Prepared by Ellen Parker	Aircraft Make / Model All models of the Air Tractor modified by the Wipaire Fire Boss conversion	Float / Ski Model 10000 amphibious	Page 1 5
FAA Reviewed <input checked="" type="checkbox"/>	Title Forward Strut Attach Bulkhead Fatigue Crack

SERVICE KIT: 78

STRUT ATTACH ASSEMBLY BULKHEAD, MODEL 10,000

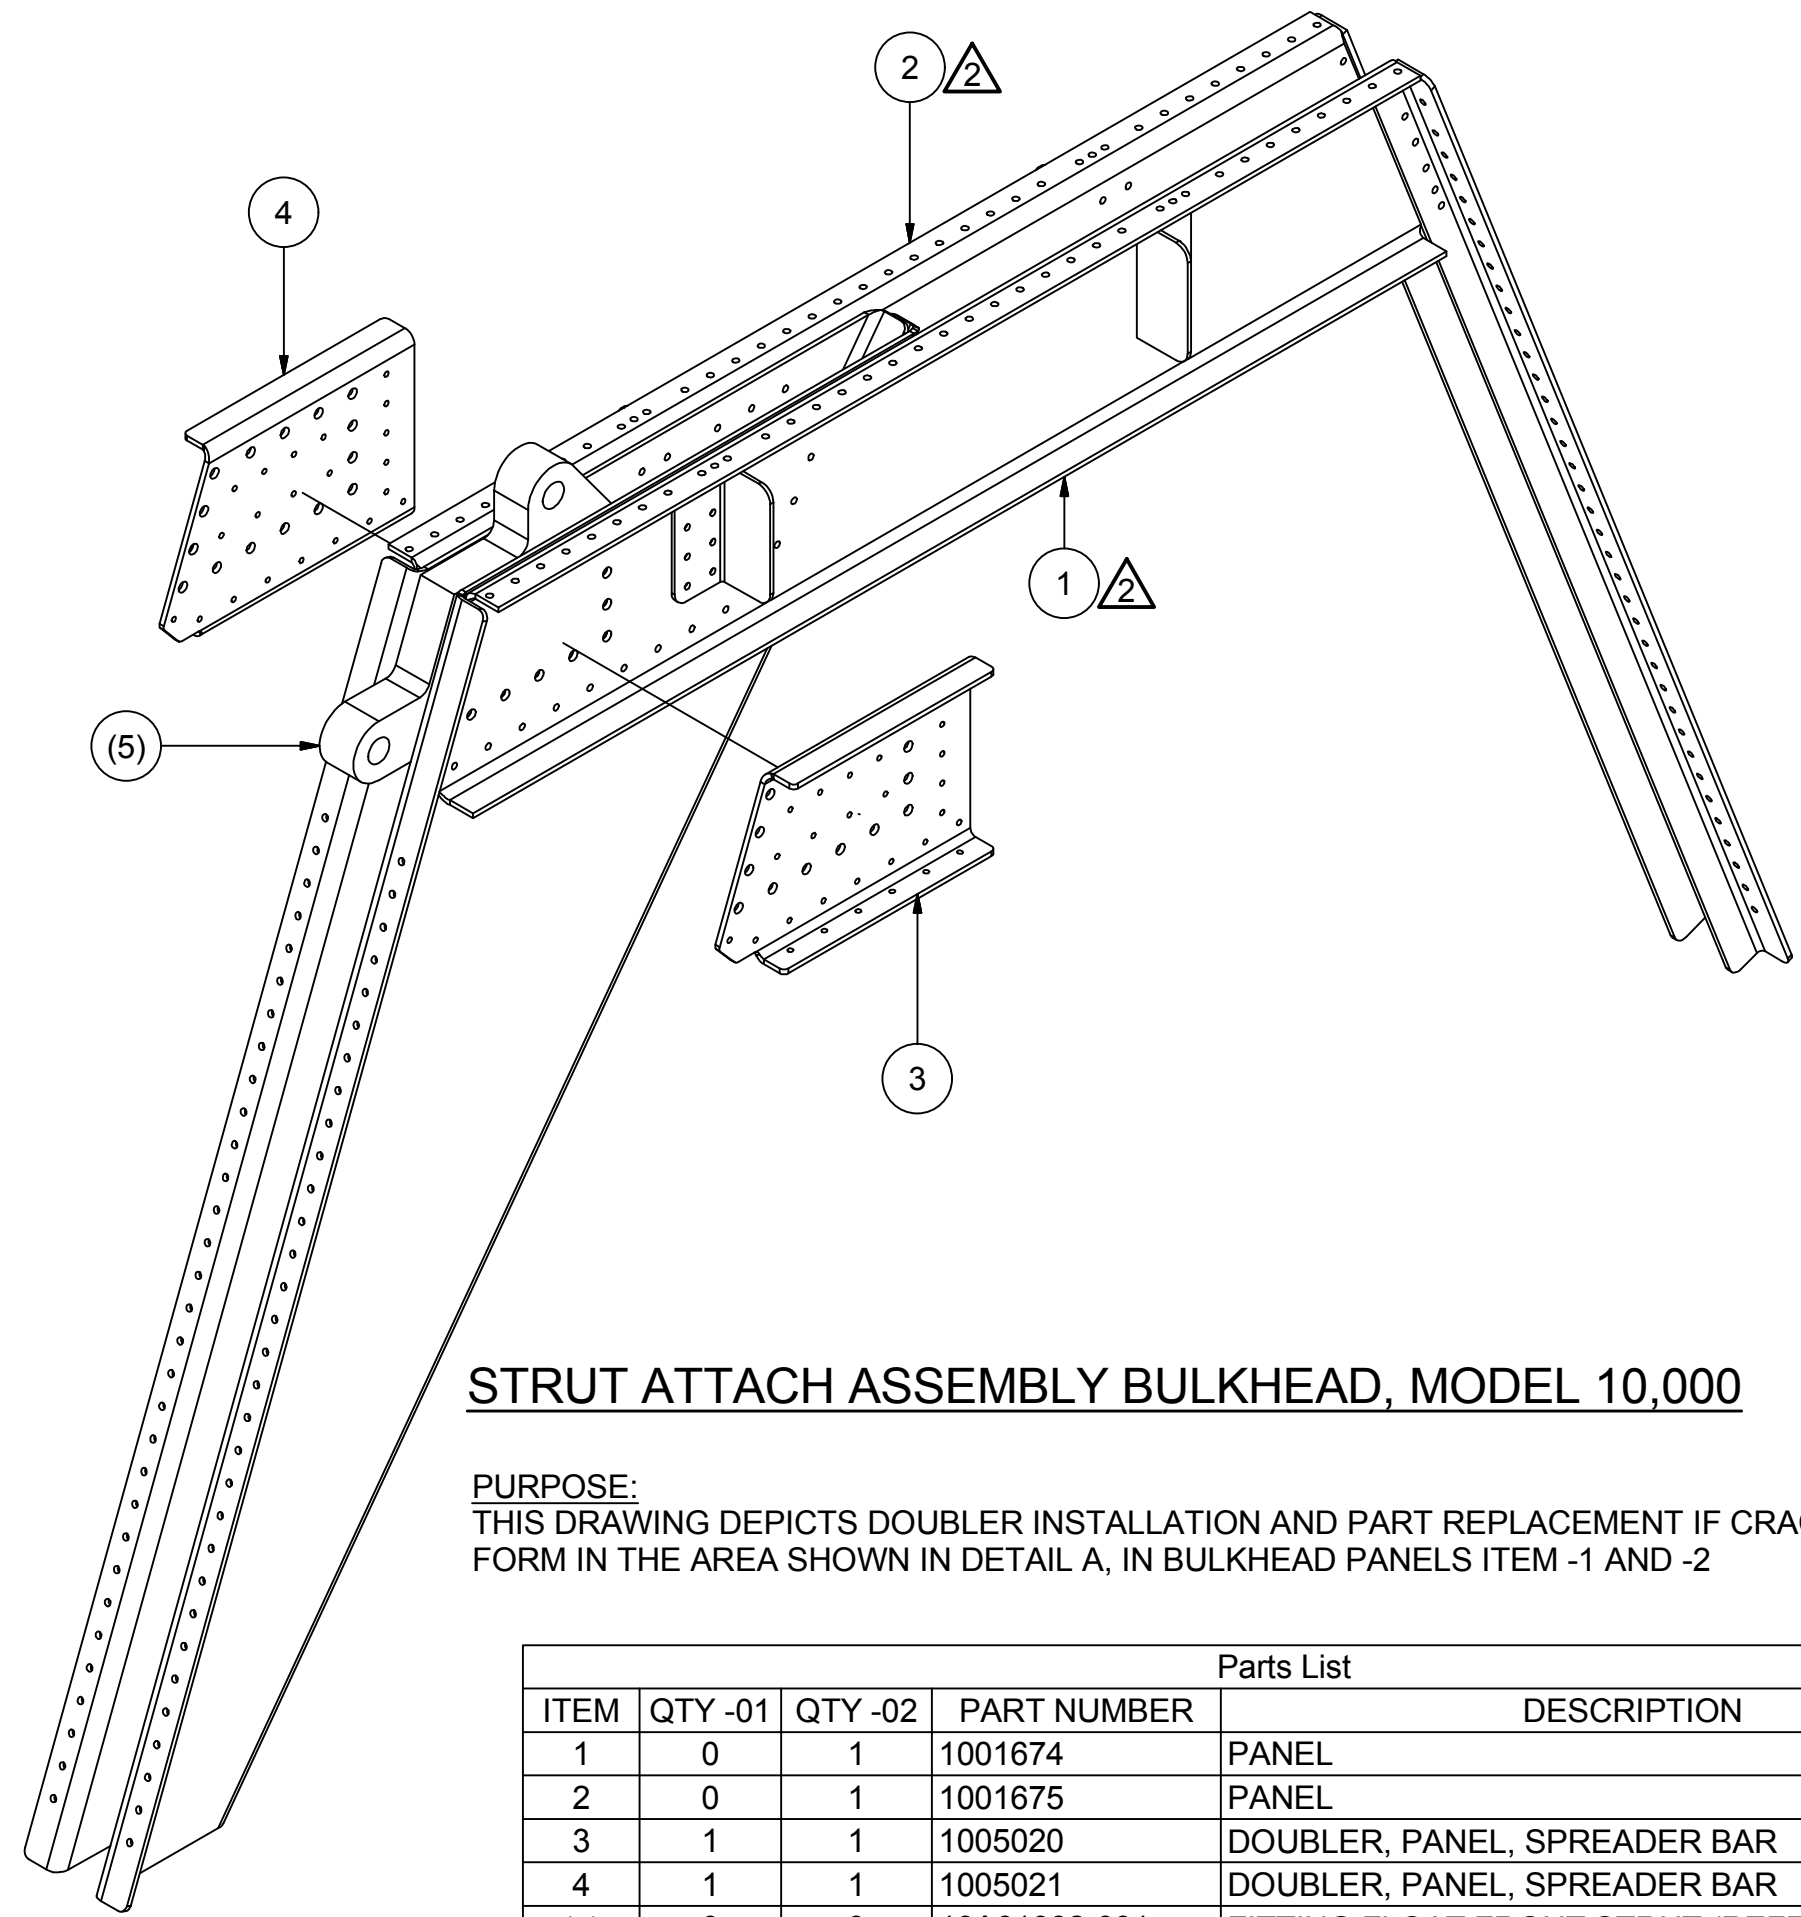
COMPLIANCE METHOD	<p>The inspection can be visual and should include both sides of the bulkhead, closely examining the bolt holes in the area indicated on drawing 1005016. Repairs if necessary are outlined on attached Wipaire Drawing 1005016 and this Service Kit. Two versions of the service kit are available:</p> <p>1005016-01 - Doublers and associated hardware only (no cracks found) 1005016-02 - Doublers/Bulkhead Replacement Panels/Repair Kit and associated hardware (if cracks are found)</p>
SHOP HOURS	Approximately 8 hours for installation of 1005016-01 per float. Approximately 40 hours for cracked panel removal and installation of 1005016-02 per float.
WARRANTY	No warranty offered.
NOTES	Special tools required: Right angle drill, right angle CherryMax rivet puller

THESE PARTS MUST BE REPLACED IF CRACKS ARE FOUND

THIS MODIFICATION ADDRESSES CRACKING OF ITEMS ① AND ② IN THIS AREA ONLY.

PURPOSE:
THIS DRAWING DEPICTS DOUBLER INSTALLATION AND PART REPLACEMENT IF CRACKS FORM IN THE AREA SHOWN IN DETAIL A, IN BULKHEAD PANELS ITEM -1 AND -2

USE CHERRY MAX CR3213-5 OR CR3253-5 RIVETS IN THESE HOLES AS NECESSARY. LENGTH AS REQUIRED

TO INSTALL THE RECOMMENDED DOUBLERS WHEN NO CRACKS ARE FOUND:

1. REMOVE FRONT AIRCRAFT STRUTS FOR ACCESS TO TOP DECK- HOIST/SUPPORT AIRCRAFT AS NECESSARY TO DO THIS.
2. USE FIGURE 1, INSTRUCTIONS FOR BULKHEAD ACCESS HOLES IN SERVICE KIT 78, AS NECESSARY.
3. DRILL OUT NECESSARY EXISTING RIVETS AND REMOVE BOLTS FOR THE STRUT FITTING.
4. PUT DOUBLER (1005020/1005021) INTO POSITION, ALIGN TO PANELS (1001674/1001675) AND FITTING USING 0.250" BOLTS. REAM HOLES USING 0.250" REAMER TO AID IN ALIGNMENT AS REQUIRED.
5. MATCH DRILL PANEL 1001674/1001675 THROUGH NEW DOUBLER HOLES.
6. MATCH DRILL DOUBLER 1005020/1005021 THROUGH TOP DECK HOLES.

TO INSTALL THE RECOMMENDED DOUBLERS WHEN CRACKS ARE FOUND:

3. DRILL OUT ALL RIVETS ON PANELS 1001674/1001675 AND REMOVE BOLTS FOR THE STRUT FITTING.
4. THE TOP DECK RAIL MUST BE CUT TO REMOVE PANELS 1001674 & 1001675. REFER TO FIGURES 2 AND 3, INSTRUCTIONS FOR DECK RAIL SPLICING, IN SERVICE KIT 78, AS NECESSARY.

5. REMOVE CRACKED PANELS FROM FLOAT.
6. FIT DOUBLERS ON NEW PANELS BEFORE REPLACING PANELS IN FLOAT.
7. PUT DOUBLER (1005020/1005021) INTO POSITION & ALIGN TO PANEL (1001674/1001675) USING 0.250" BOLTS. REAM BOLT HOLES USING 0.250" REAMER TO AID IN ALIGNMENT AS REQUIRED.

8. WITH BOLTS INSTALLED, MATCH DRILL PANEL 1001674/1001675 THROUGH NEW DOUBLER HOLES, CLEAN AND DE-BURR HOLES.
9. WITH BOLTS INSTALLED, MATCH DRILL DOUBLER FLANGES THROUGH EXISTING PANEL HOLES, CLEAN AND DE-BURR HOLES.

10. REINSTALL NEW PANELS/DOUBLERS INTO FLOAT AND INSTALL BOLTS THROUGH FWD DOUBLER, PANELS, FITTING, AFT PANELS, AND DOUBLER.
11. WITH DOUBLERS, PANELS, AND FITTING BOLTED TOGETHER, RIVET PANELS BACK INTO FLOAT. INSTALL SOLID RIVETS WHEN IT IS POSSIBLE AND CR3213 OR CR3253 WHEN IT IS NOT.

12. COMPLETE TOP DECK SPLICE REPAIR, REFER TO FIGURES 2 AND 3 IN SERVICE KIT 78.
13. COMPLETE PATCH OF SIDE SKIN HOLE, IF NECESSARY, REFER TO FIREBOSS SERVICE MANUAL FIGURE 10.1.
